Sheet: /
 File: ikoka-stick-meshtastic-device.kicad_sch

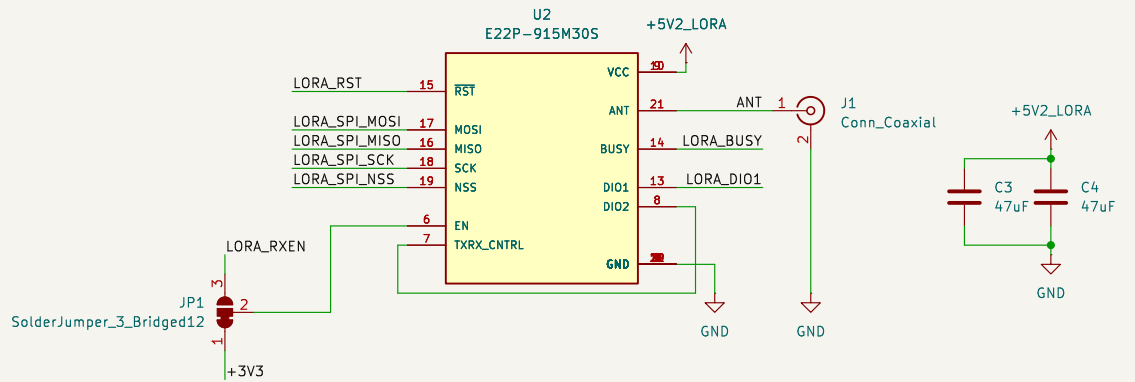
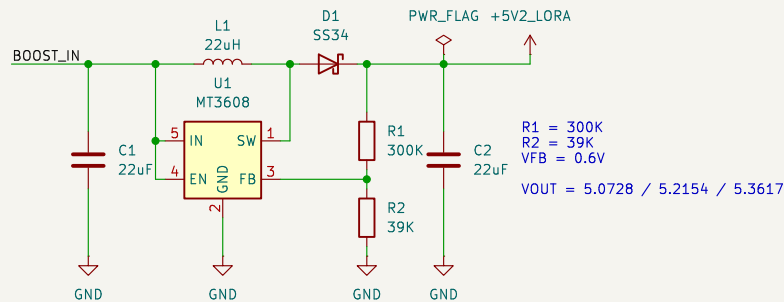
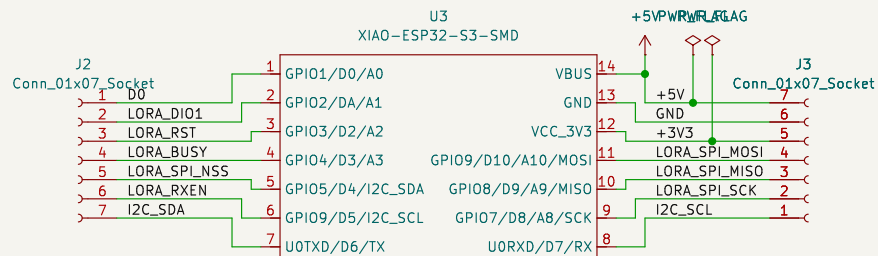
E22 Module uses pin 6 as RX_EN and is connected to SX126X_RXEN in firmware
 In order to use the E22P with stock firmware, pin 6 must be high

You can do this in software with or change the routing like above
<https://github.com/yellowcooln/MeshCore-washtastic-e22p/commit/3ebd5f18f94eb0c87fe2e88f7eaa14b53440a2b4>
